AGENDA

The Columbia Architectural Design Review Team will meet on Tuesday, June 7th, 2022 at 8:00 a.m. in Conference Room A on the basement level of City Hall, 700 N. Garden Street to consider the following:

ART 22-0142

**Trotwood
 Retail Center**

1 Front Elevation
 A 3.1 3/16" = 1'-0"

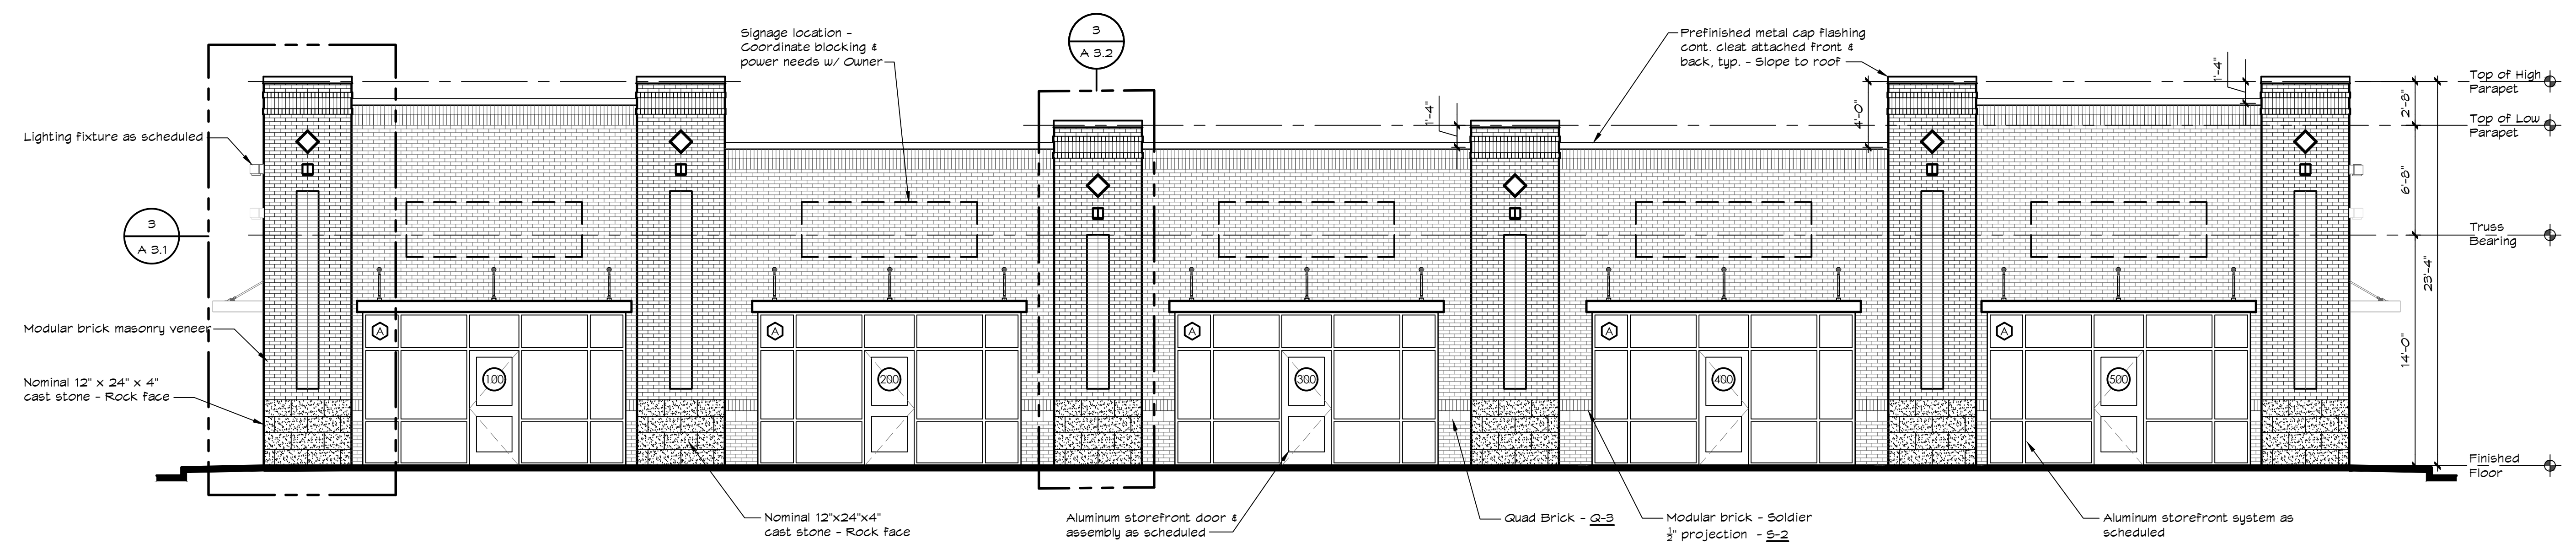
- The proposed west (rear) building elevation will consist of a primary façade material of brick accented by brick soldiering within the base and the columns. Each individual pilaster will be accented by a stone medallion detail. Aluminum storefront windows will be facing the Cayce Lane elevations. The front elevation will consist of the same primary façade materials as the rear elevation with a combination of brick details separated by brick pilasters.
- The right and left (side) elevations will consist of a primary brick material as all other elevations with a 4' recessed parapet.
- It shall be recommended that as a condition of approval that all rooftop HVAC equipment be screened by the raised parapet with no exterior visibility.
